Peartree+Belli Job #: 20035

**SHERWOOD ELEMENTARY SCHOOL  
NEW BUS DROP-OFF, ACCESSIBLE RAMP AND RESTROOM MODERNIZATION  
110 S. WOOD STREET, SALINAS, CA  
SALINAS CITY ELEMENTARY SCHOOL DISTRICT  
BID ADDENDUM #1R**

DSA Approved Addendum #01  
for  
ADDED  
Staff Restroom Scope

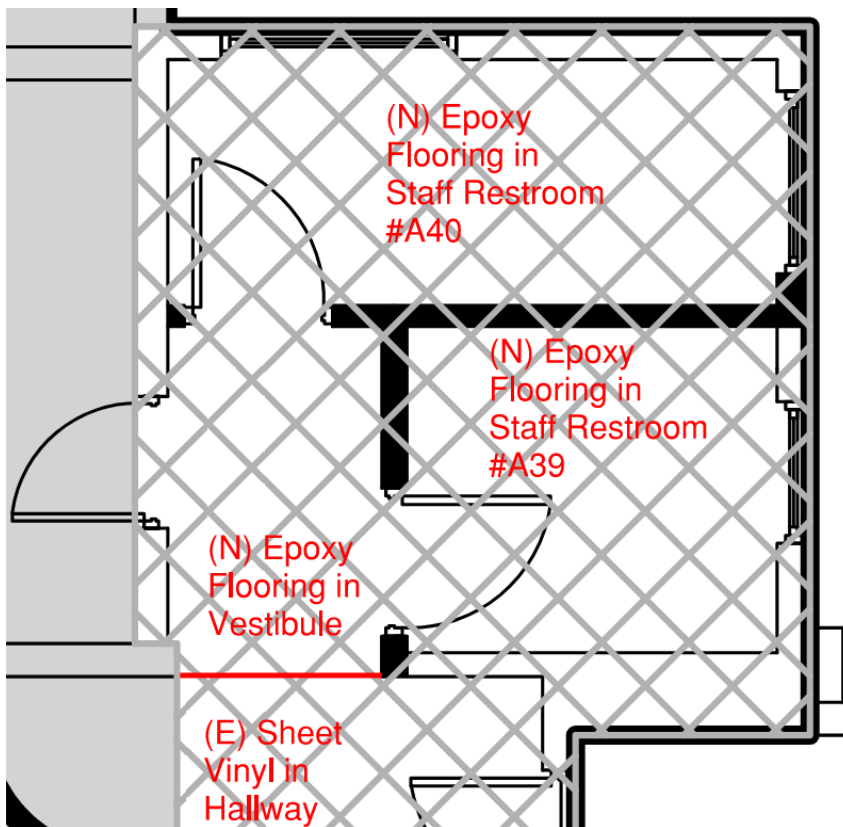
15. Q: Floor Plans show windows at restrooms. Interior elevations do not show windows. Are windows getting removed?

**A: All existing windows to remain. New furred out plumbing walls to be framed out around existing windows.**

DEMO & PROPOSED FLOOR PLAN & ELEV. - STAFF RR A42  
 NEW BUS DROP-OFF AND PARKING FOR  
**SHERWOOD ELEM. SCHOOL**  
 110 SOUTH WOOD STREET  
 SALINAS, CA 93905

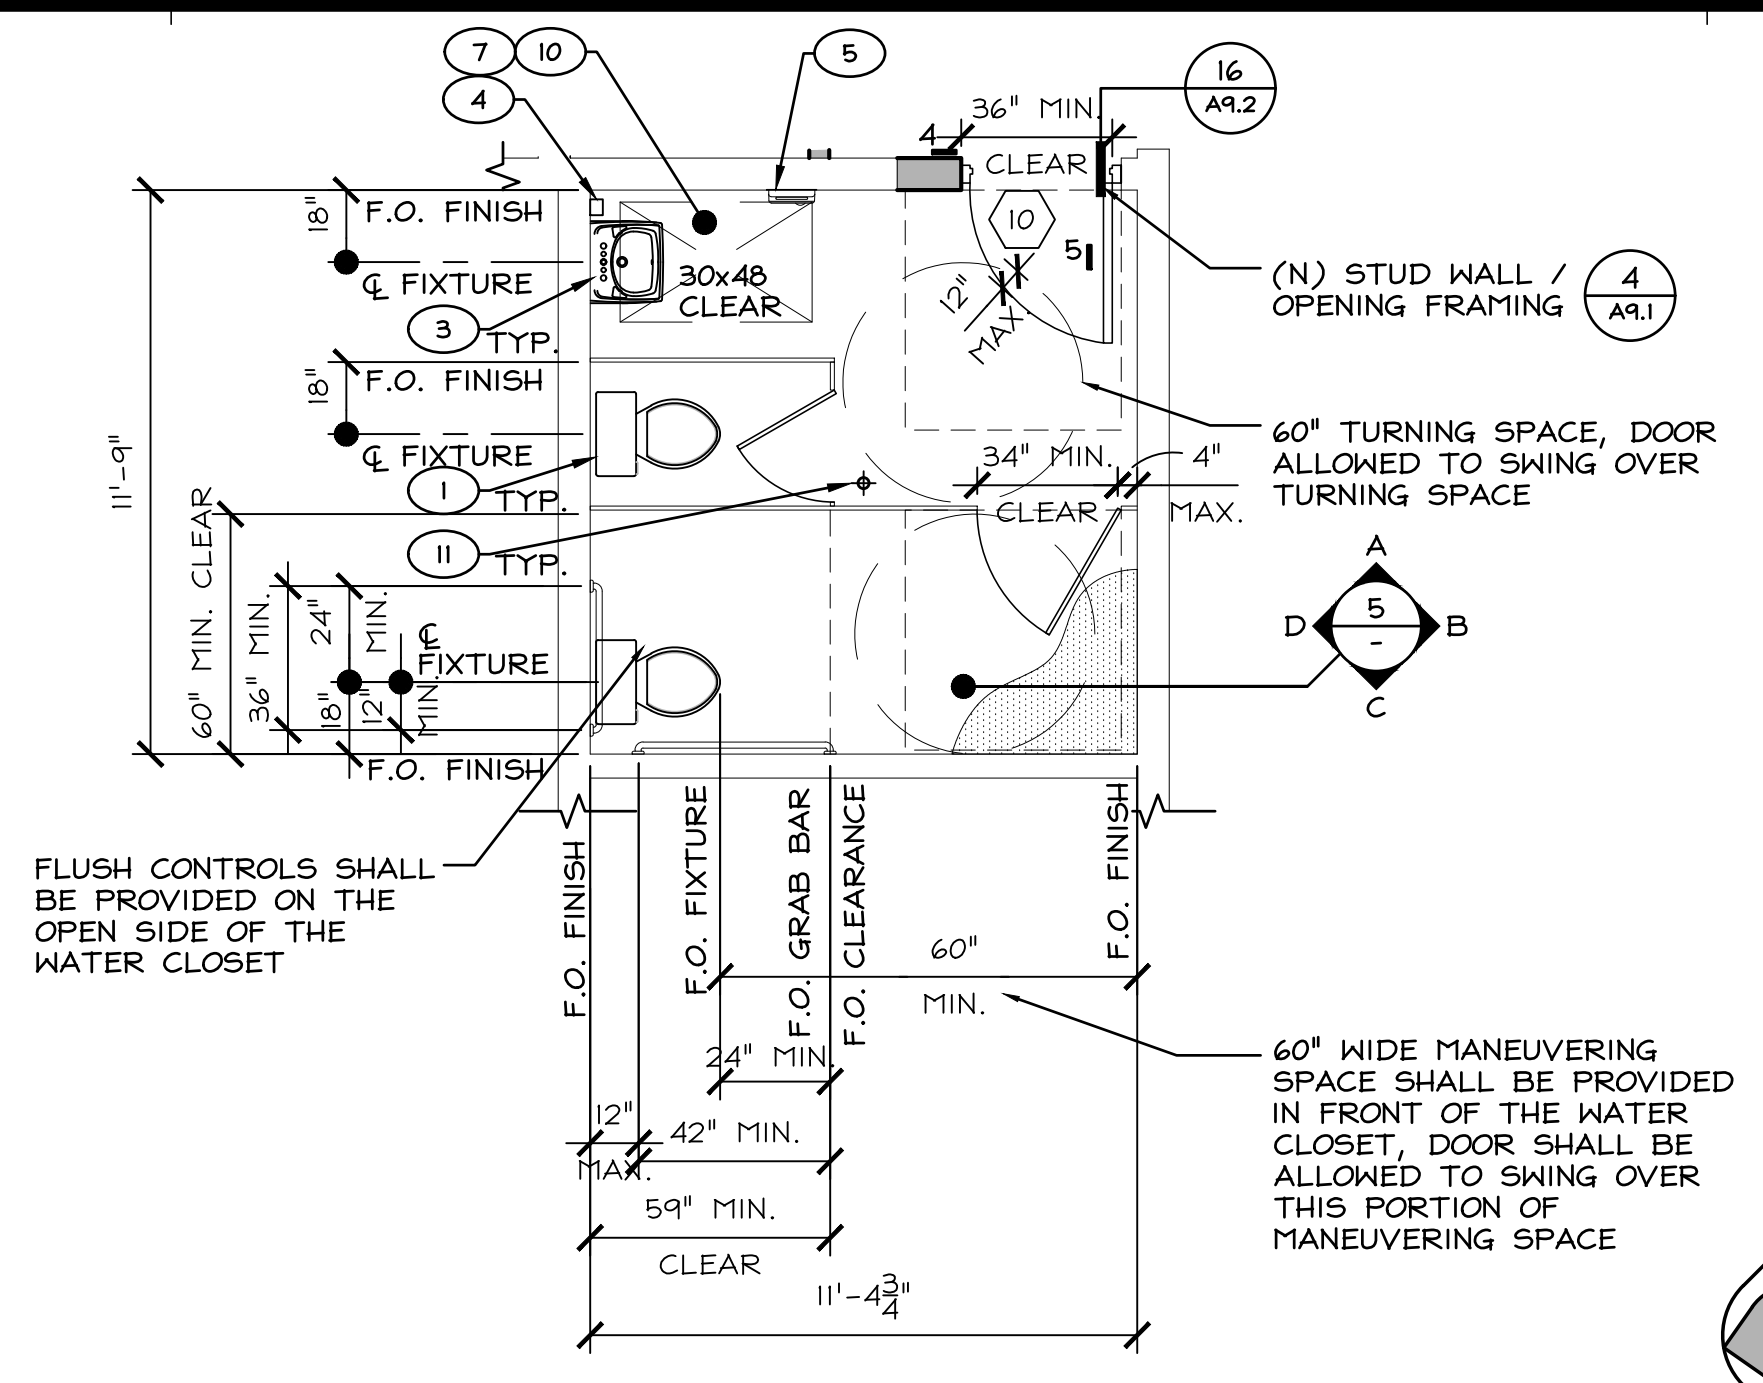
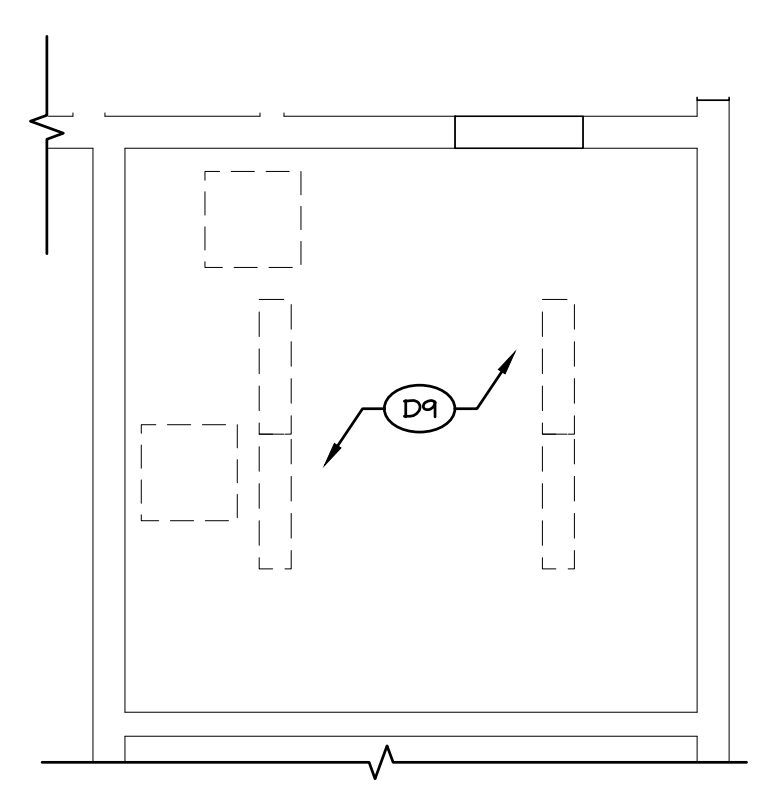
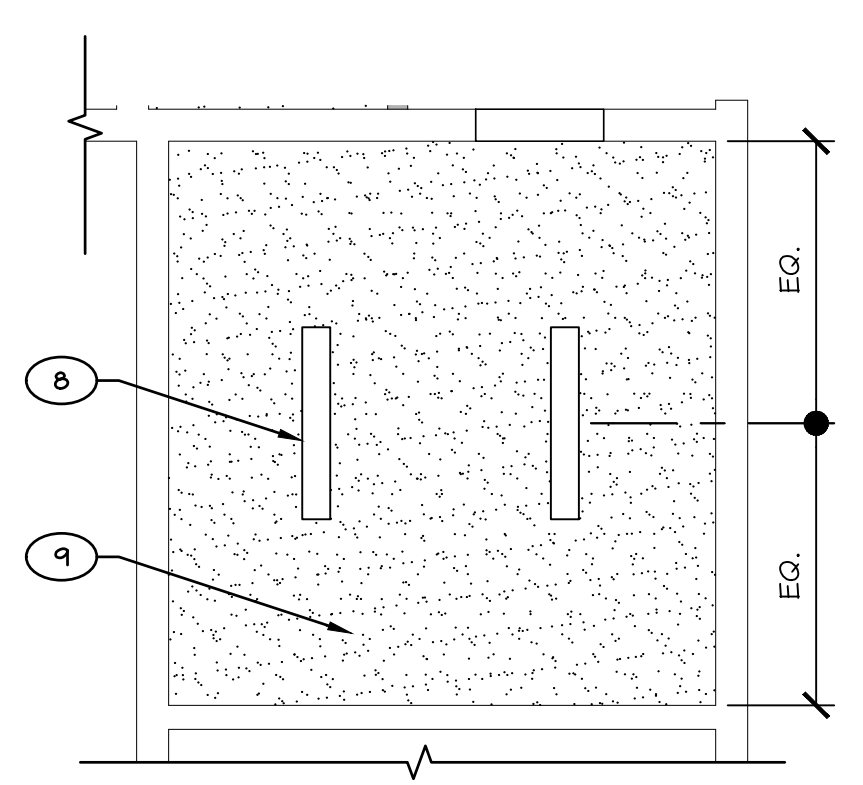
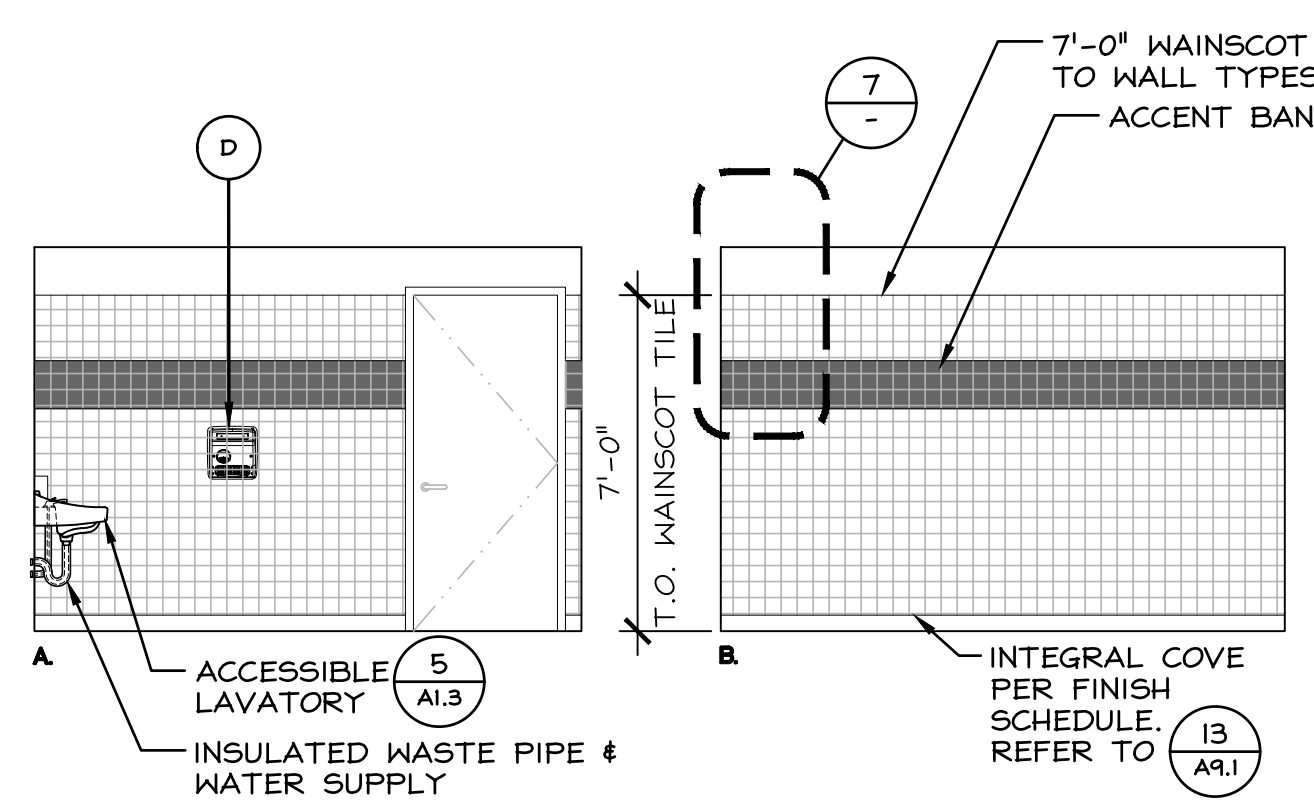
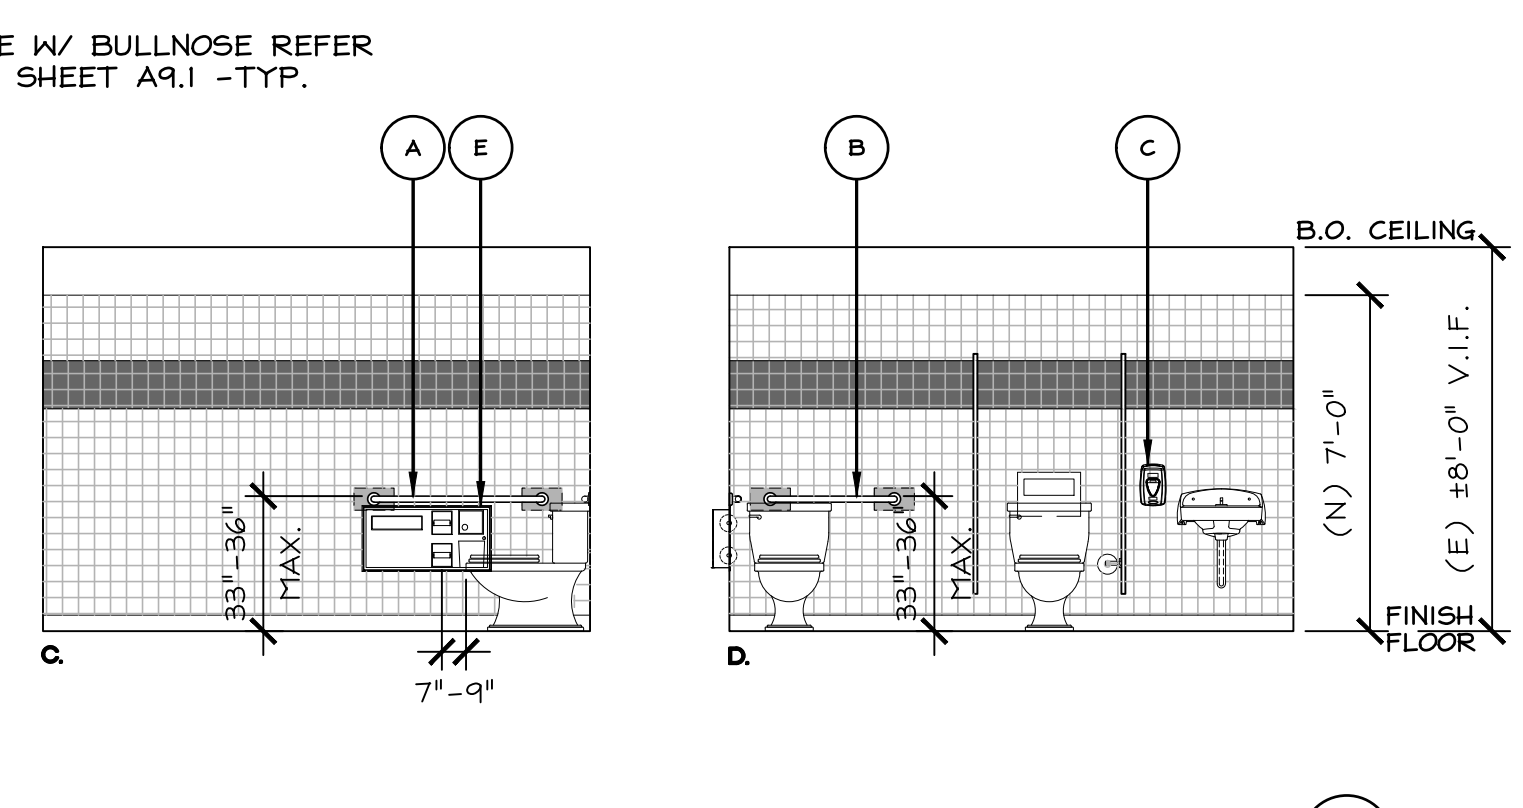
Provide a brief description of construction scope for this post-approval document (attach additional sheets if needed): <b>Addendum submitted to include one additional Staff Restroom into Scope of Work. We are proposing to convert an existing storage room into Staff Restroom. Fire alarm cut sheets provided as well.</b>			
List of DSA-approved drawings affected by this post-approval document: <b>T1.1, A1.1, A2.7 (added new sheet), A3.1, P0.1, P1.1, P2.1, E3.1, E4.1, E5.1, FA0.1, FA1.1 and FA4.1.</b>

# Door Jamb Detail

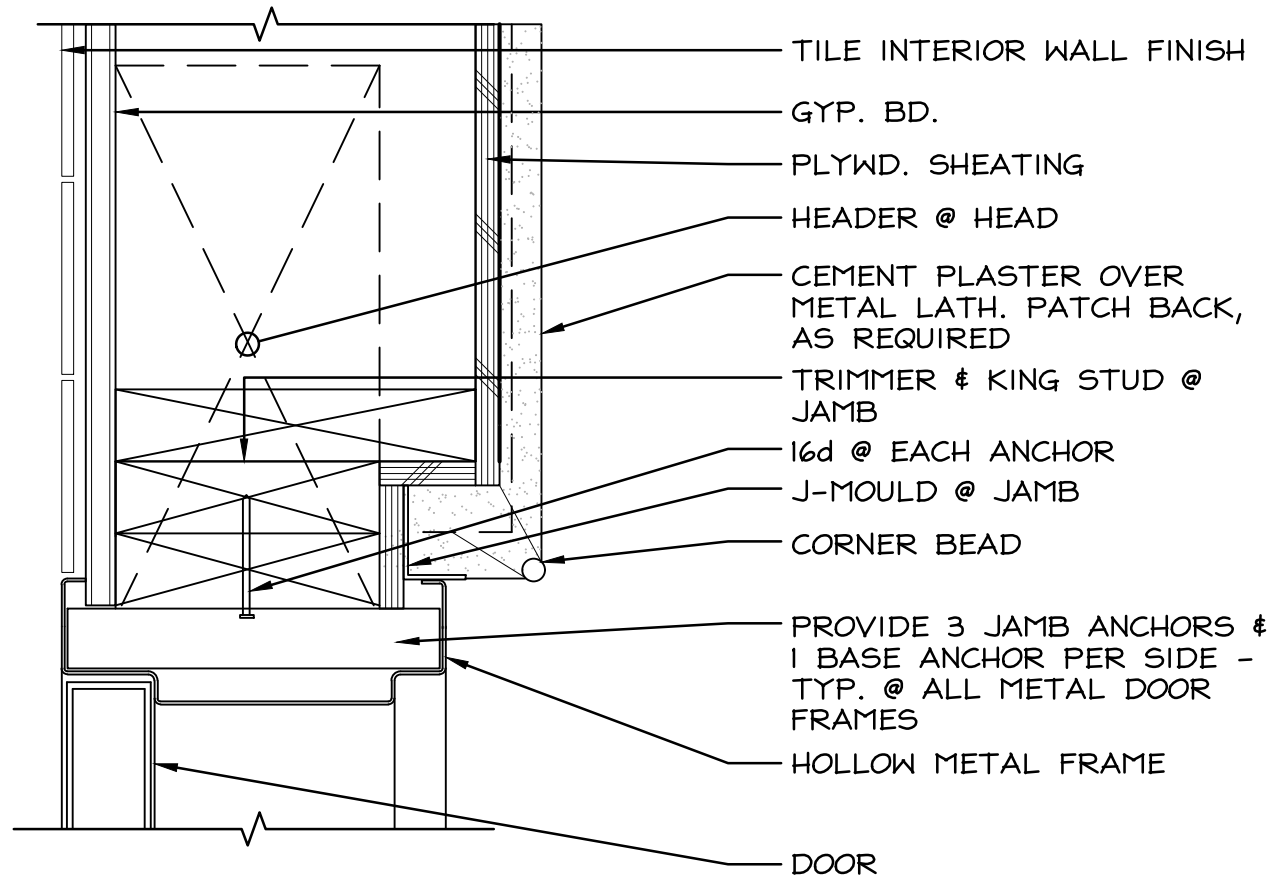
16. Q: How shall restroom wall tile align with door jambs?

17. Q: How will new door jamb tie in to thickened wall conditions?  
**A: New exterior door frame now detailed for existing thickened wall condition. See Hollow Metal Frame detail attached.**

**A: Door jamb detail now provided. Tile to be butted up against door jambs with clean grout line separation. See Hollow Metal Frame detail attached.**
